TO: Historic Preservation Board **Item Number:** 2
FROM: Department of Doing, Planning Staff **DATE:** March 07, 2017

SUBJECT: Petition HP-17-06a. Kurt & Renee Strauss, owners. Certificate of Appropriateness for exterior rehabilitation of single-family house. Work includes replacement of vinyl siding with stucco, replacement of doors and windows, replacement of structurally deficient chimney and rear bedroom addition, installation of exterior fencing, replacement of existing accessory structure, and a zoning modification request for accessory structure setbacks. Located at 1216 NE 4th Street. This building is non-contributing to the Northeast Residential Historic District.

8 (bottom): View of rear porch addition from northwest corner of lot.

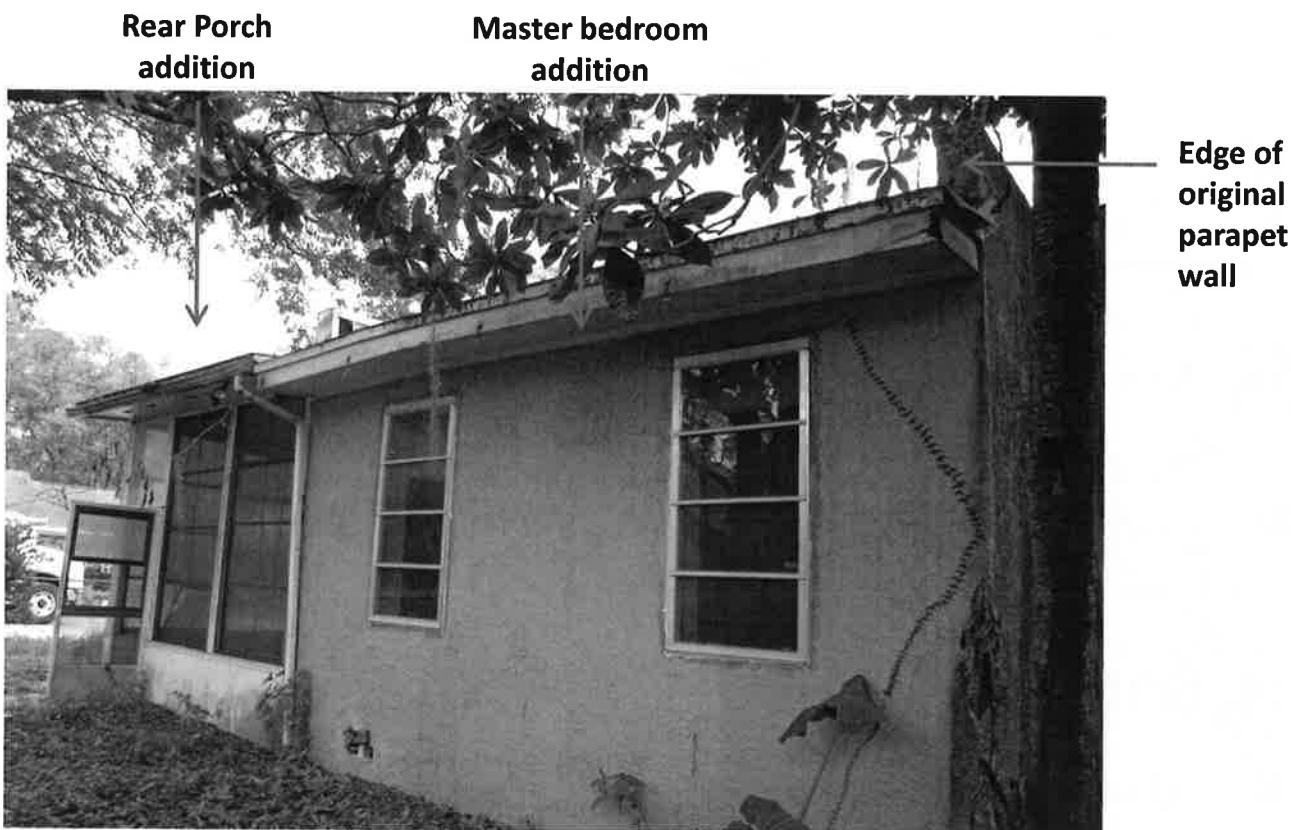
The rear porch was likely added around the 1980s, enclosing the northwest corner of the house and constructed as flush with the wall of the original kitchen bay on the north and the wall of the master bedroom addition on the west. The condition of the porch is fairly dilapidated.

The Owner proposes to remove the screen porch and add an enclosed room in its footprint, allowing for a master bathroom and a laundry room (connected to the kitchen) in plan.

Staff finds the removal of the screen porch to be appropriate as it is not historic and its condition is poor. Staff also finds the proposal for enclosing this area for a laundry room and bathroom as an appropriate addition to a house, scope that is seen often in additions to historic homes. However, Staff is concerned that the new addition is flush with both the kitchen wall and the master bedroom wall, that the new windows of the kitchen will connect the original bay wall to the new wall, and that the stucco finish and extension of the roofline/parapet from the original house all add to the appearance of this addition as being original to the house. If this addition was removed in the future, the original bay would not be evident in any way.

Staff understands that the floor plan of the kitchen, laundry room and bathroom are compact and there is not a lot of room for removal of square footage in these areas. However, Staff recommends a small redesign of the addition to differentiate it from the original kitchen bay and master bedroom addition. The addition could be recessed back from both walls by a few inches, creating a reveal that would acknowledge the original bay and master bedroom

addition's location. Materials could be different but sympathetic to the original and the roofline/ parapet could be shorter than the original house.

15: Original chimney and fireplace are structurally deteriorated and do not meet code requirements. Chimney is leaning and hearth tile is cracked and sinking.

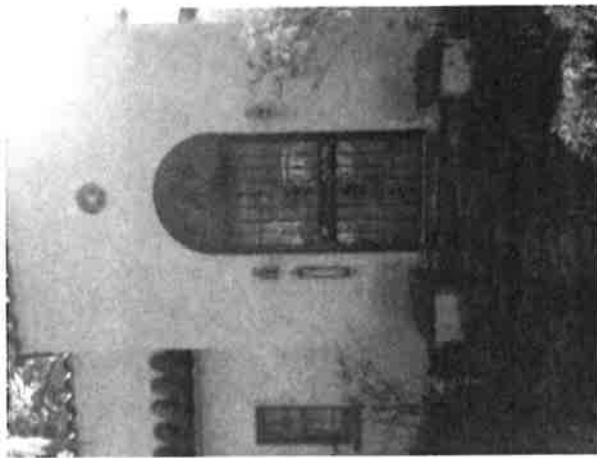
The existing chimney is a masonry structure with stucco exterior. It is original to the house, but leaning and sinking, as is visible in the exterior photos and in the cracking of the hearth tile. The Owner has had masons examine the chimney for repair or rebuilding but the deterioration would require complete rebuilding without assurance that the chimney and hearth wouldn't sink again. The Owner proposes to remove the existing chimney and rebuild the hearth,

chimney box and chimney to match the appearance of the original. The new chimney would be constructed of wood framing, with exterior stucco. The dimensions of the firebox would need to be slightly deeper in plan in order to meet code.

Staff finds the proposed rebuilding appropriate per SOIS #6: *Deteriorated historic features shall be repaired rather than replaced. Where the severity of deterioration requires replacement of a distinctive feature, the new feature shall match the old in design, color, texture and other visual qualities and, where possible, materials. Replacement of missing features shall be substantiated by documentary, physical or pictorial evidence.*

A1

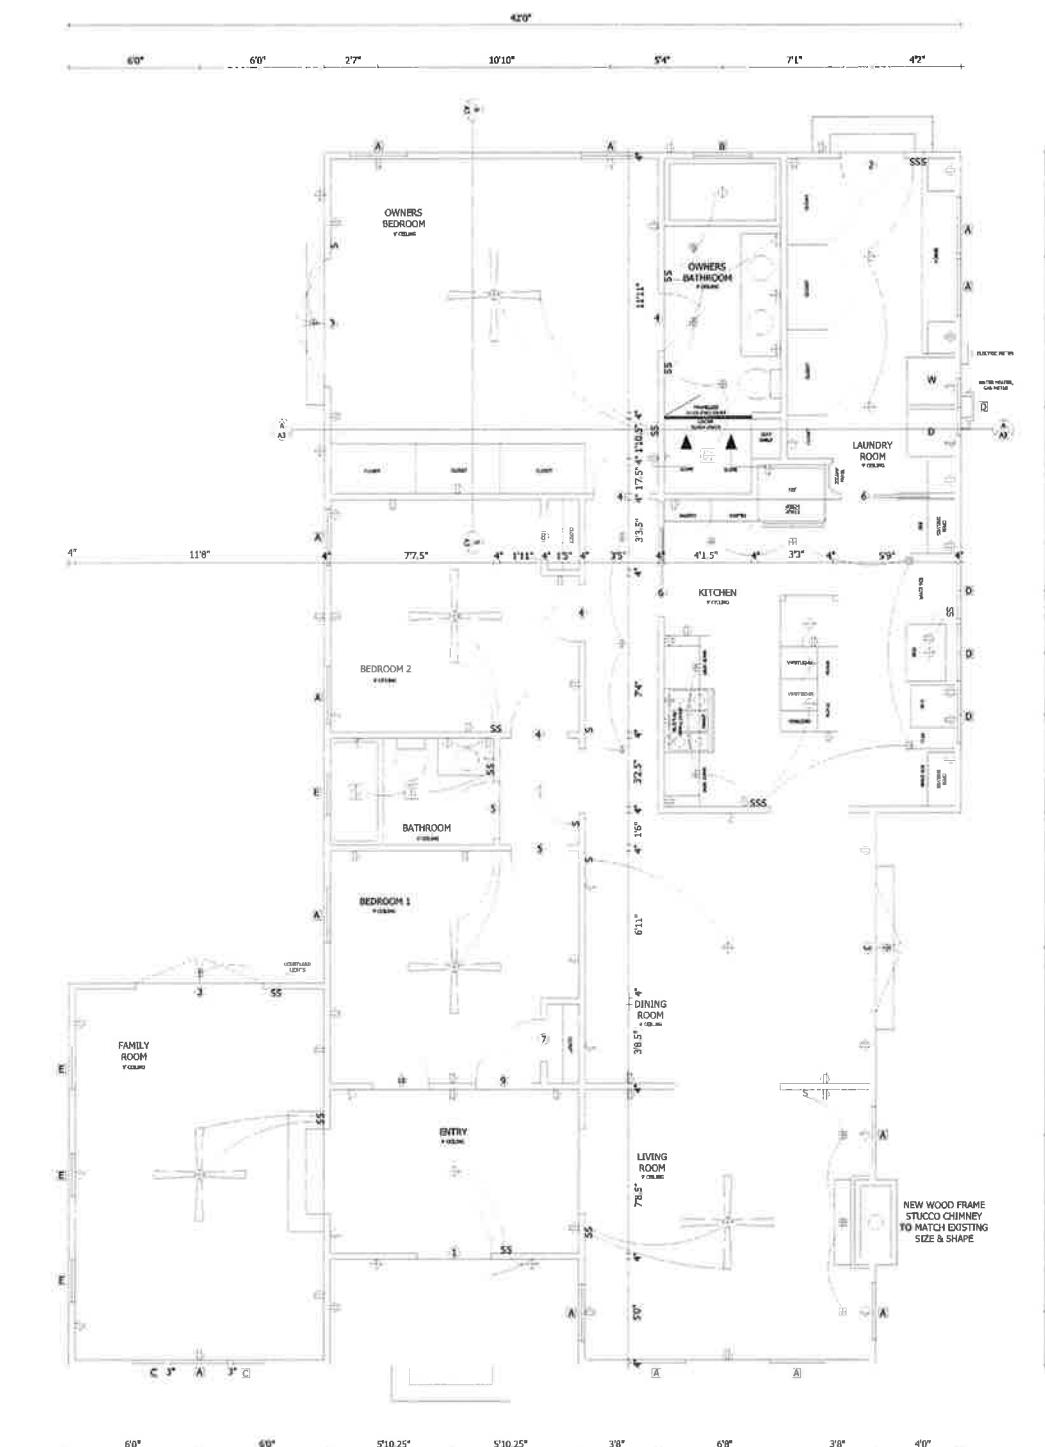
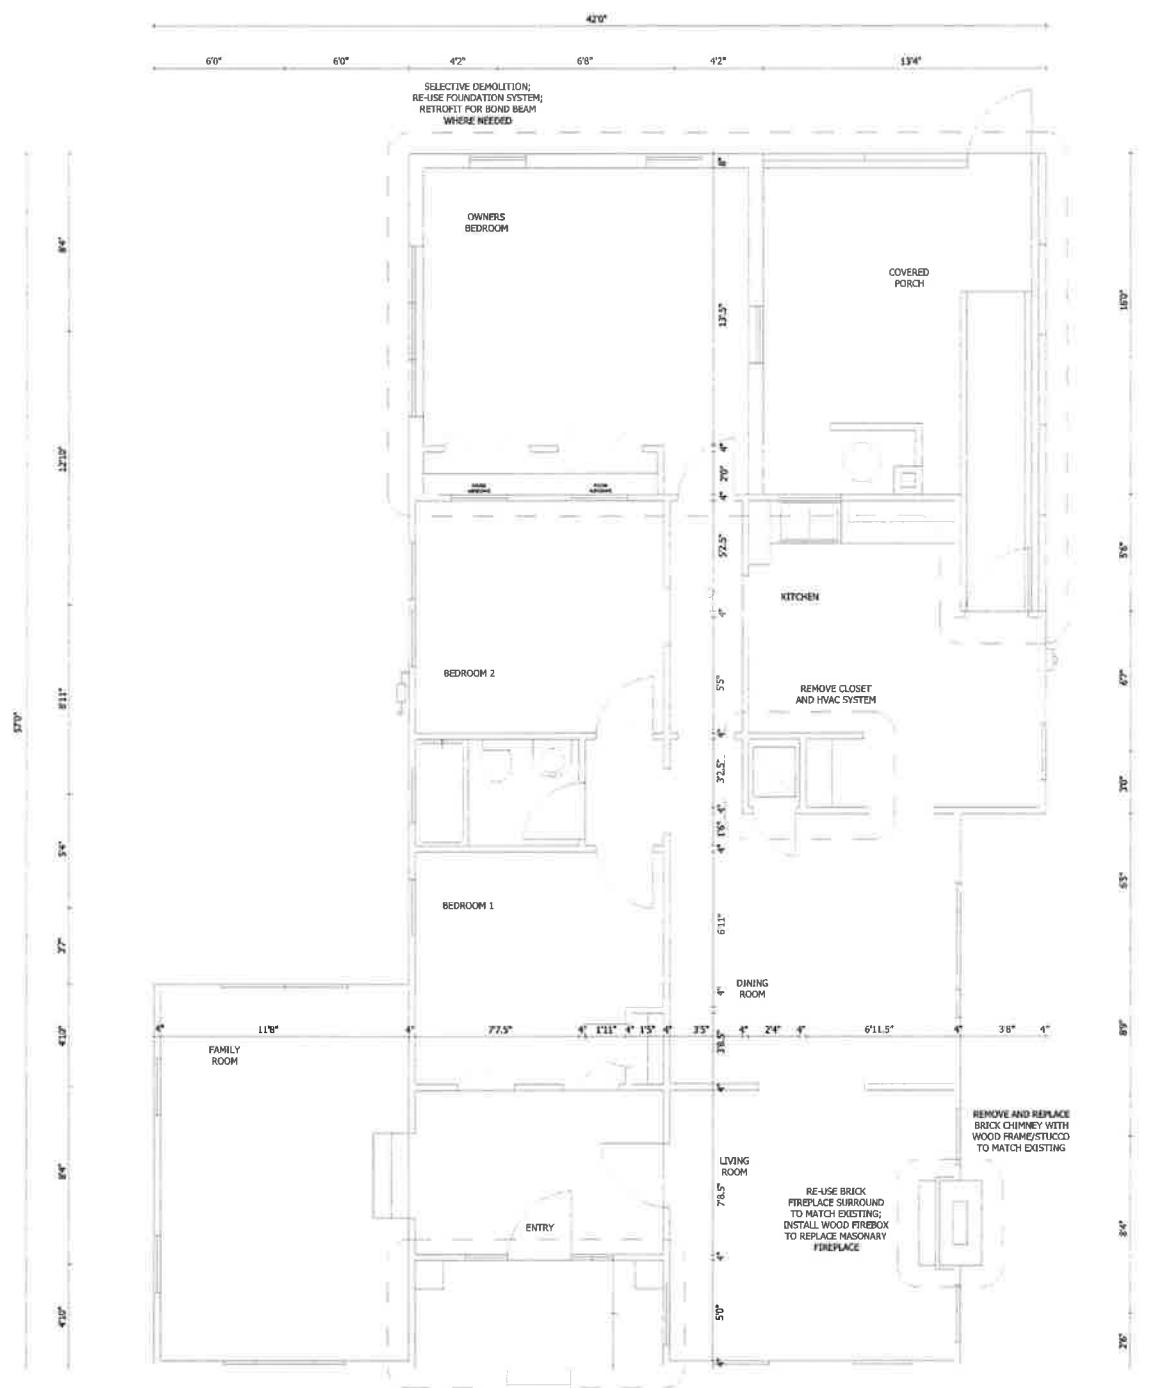
Staff recommends Board discussion on installing new door opening 1 on the north façade, as it is considered a primary façade, being a corner lot, and taken into account with the number of new openings proposed on this façade.

Staff recommends approval for the door canopies on the south and west elevations, but recommends Board discussion for the canopy on the new opening on the north façade.

Staff recommends that the board discuss the smaller windows on the south side of the family room as there is no documentary evidence of any original windows on the original carport wall and the windows will be visible from the street. Refer to the guidelines below.

Staff also recommends the board discuss the casement window configuration for the kitchen and laundry room on the north elevation. Staff recommends the board consider the window installations in conjunction with the proposed new door opening in the Dining Room and the construction of the addition to replace the rear screen porch.

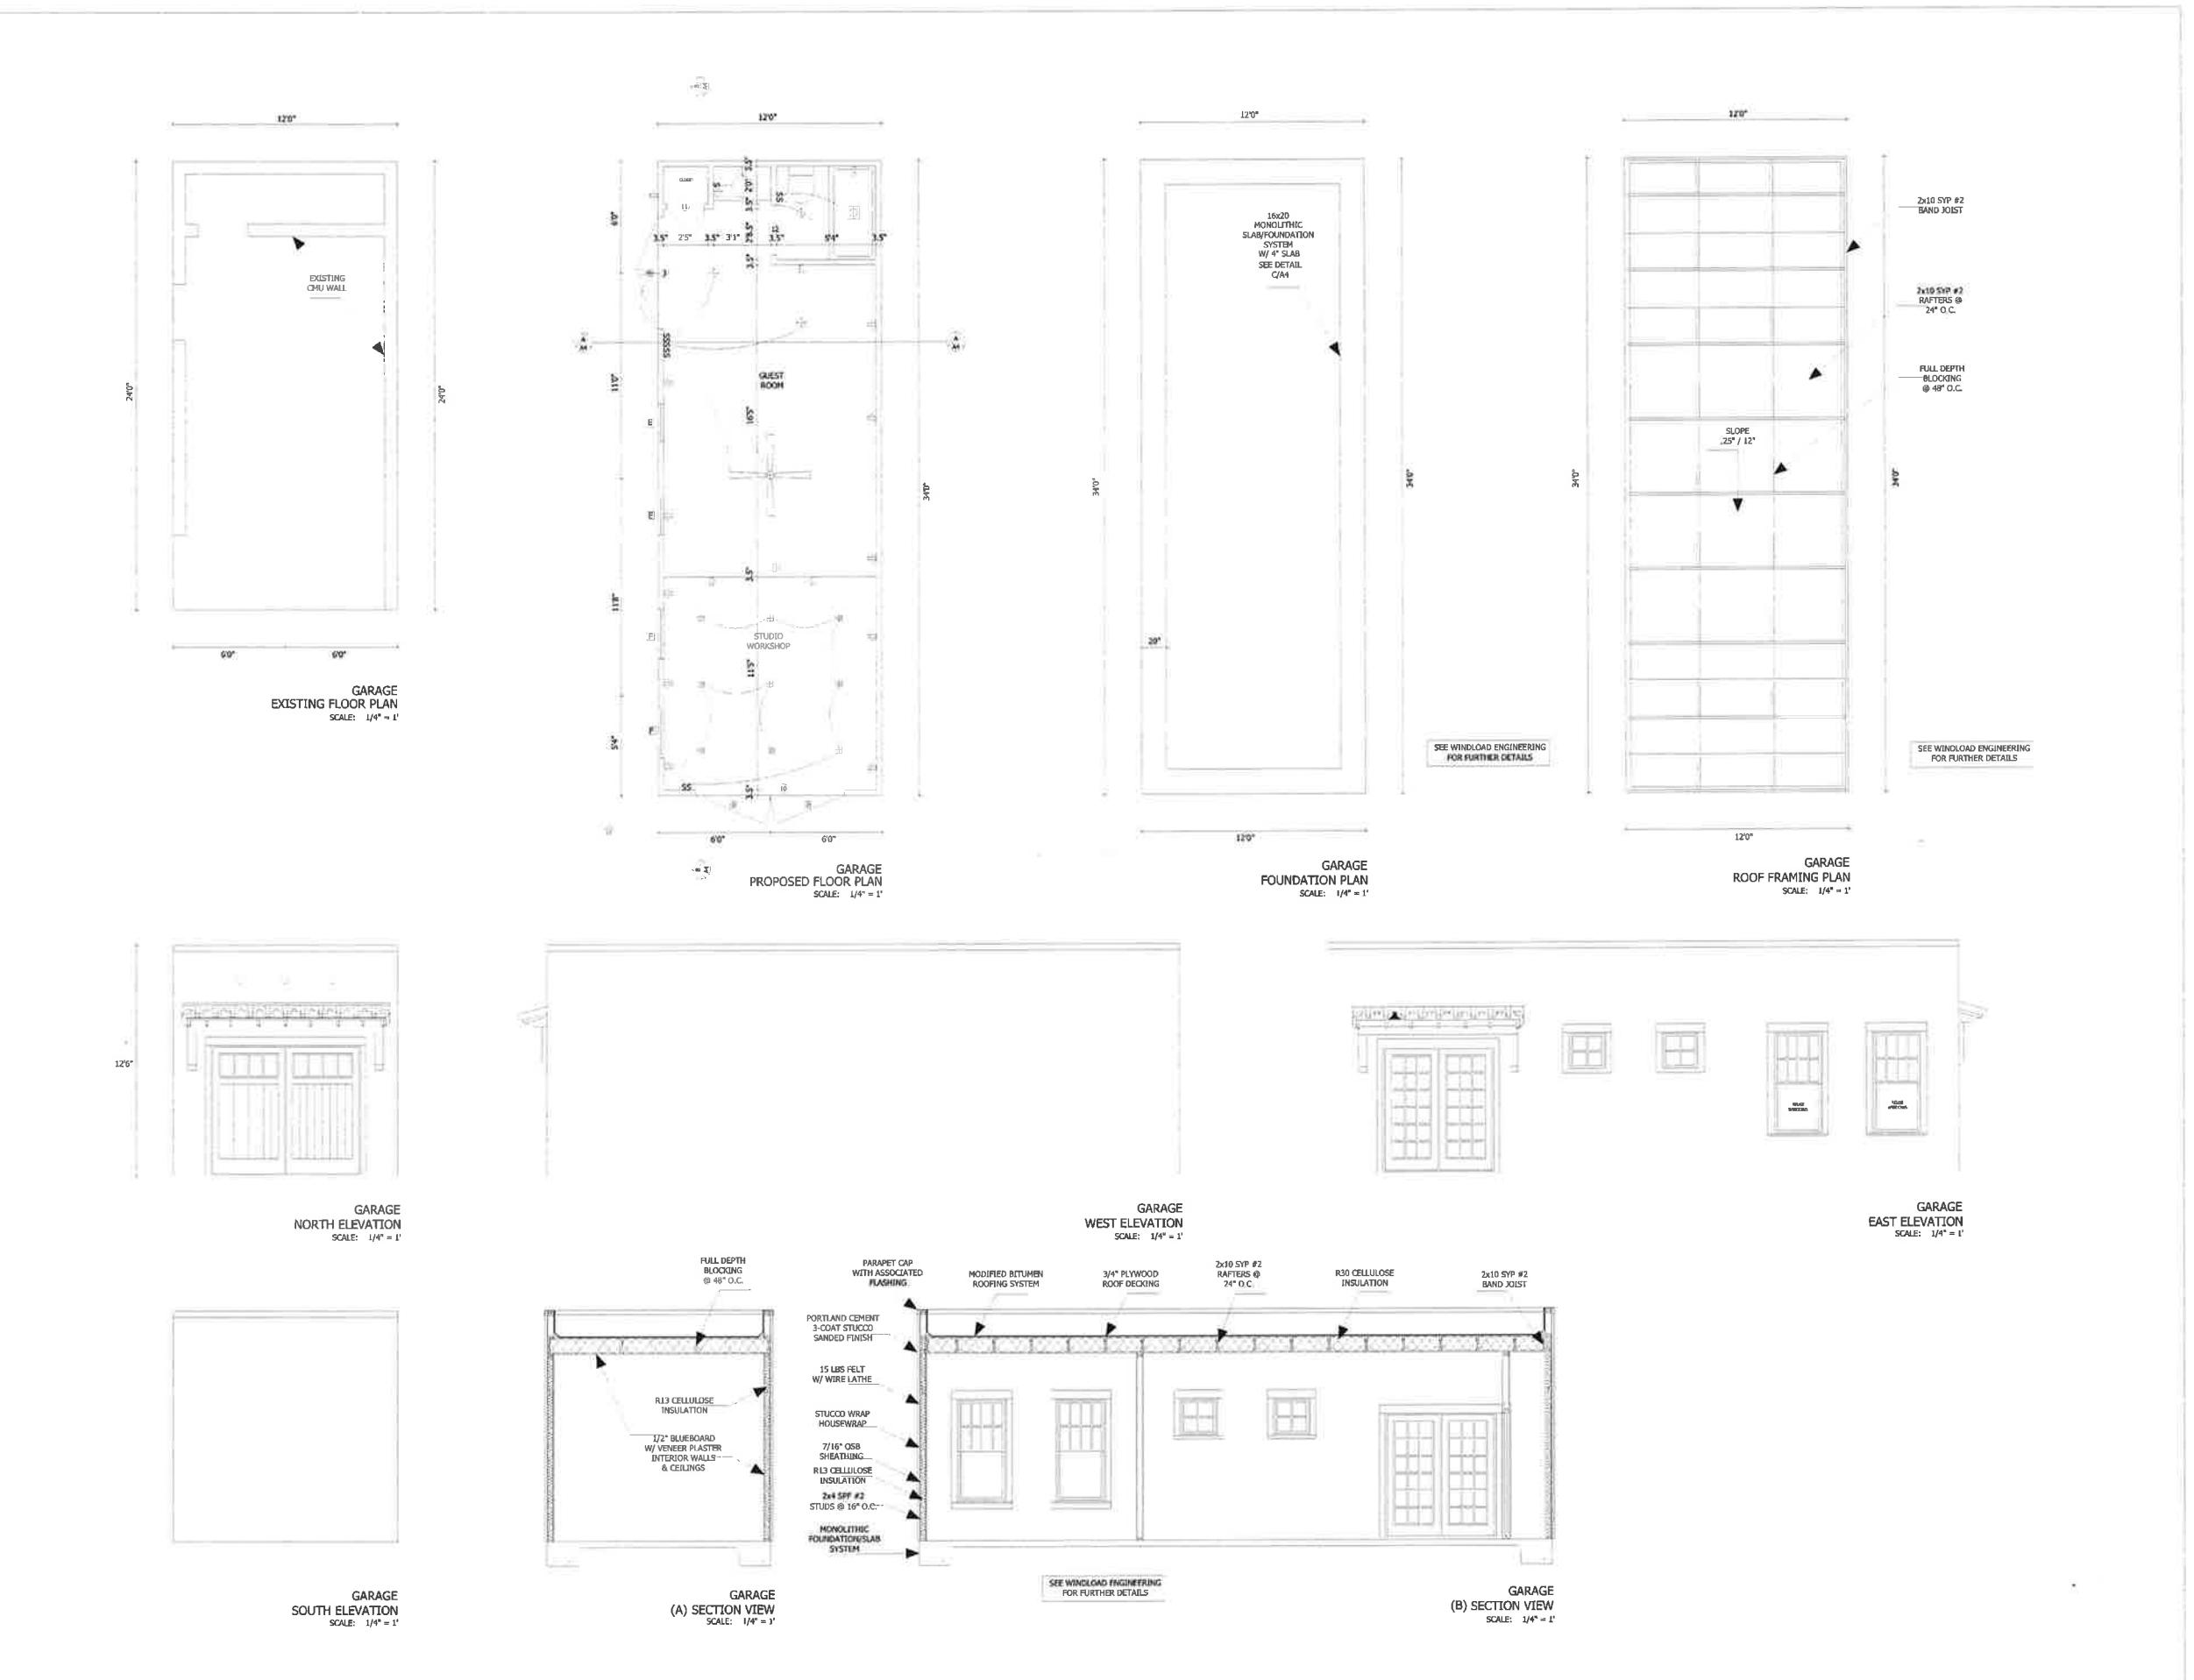
Staff finds the placement of the wall behind the house, flush with the house wall, and not on a primary façade as an appropriate location for a privacy wall to create a courtyard (private backyard) for a house located on the corner. Staff finds solid masonry and the stucco material of the wall appropriate for the architectural character of the house and that they relate to other houses of similar design in the historic district (Refer to Exhibit 2, p. 16). Staff recommends the wall height be lowered to 6'-0", which is a height that will provide privacy considering the solid character of the wall.

Staff finds the design of the new structure appropriate for its overall architectural character in that it takes its design cues from the main house. The building is located at the rear of the lot and the size does not detract from the house, especially by its proposed location in the footprint of the original, abutting the property lines (requiring a setback modification).

Per RSF-3 zoning, the rear and side yard setbacks for an accessory structure are 7.5'. The Owner is requesting 0' setback on both sides. The proposed elevations for the accessory structure will be stucco walls at 12'-6" height. Refer to Sheet A4 for drawings.

Staff finds the proposed modifications for rear and front setbacks are appropriate for the site and the historic district. Using the Land Development Code requirements as an additional basis for review, the modification "will not affect the public safety, health, or welfare of abutting property owners or the district;" the proposed change is "consistent with historic development, design patterns or themes in the historic district," as many historic accessory structures are close to or on rear yard property lines; "the proposal reflects a particular theme or design pattern that will advance the development pattern of the historic district," and "the proposed complies with utility, stormwater, access requirements and other requirements related to site design in the land development code."

- the new privacy wall height be lowered to 6'-0" per the guidelines
- submission of gate design and samples of color selection for exterior canopy tile for Staff review once designed
- landscape screening of relocated utility equipment on the north façade
- submission of front door cutsheet when selected, showing a door in proportion with the original arched opening height
- submission of any revisions to documents for permitting for Staff review, including the materials and design for the walking surface noted as TBD on the existing drawings
- Approve the *Application for Modification Existing Zoning Requirements* requesting a modification of the side and rear setback from 7.5' to 0'.
